Technical Service Bulletin

Cobra Motorcycle Mfg.

TSB1408 CX50 JR / OI radiator

May 1, 2008

Figure A

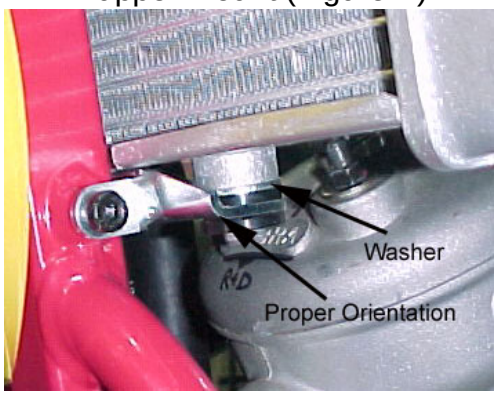
The ECMU0061 radiator for the Cobra CX50 JR & OI is being replaced with a silver one being produced by a different supplier. Besides the change in color, there is also a geometry change to the radiator. Most importantly the radiator is larger and so requires some changes to the mounting. Unfortunately the replacement radiator is unique for the JR and OI and has different part numbers.

1. The bottom radiator mount must now be mounted upside down from the previous mounting arrangement. Proper bracket orientation is shown in Figure A and there is a washer between the grommet and the radiator.
2. A spacer is supplied to aid in mounting the radiator in a true horizontal position. The spacer goes between the bracket and the frame on the upper mount (Figure B).
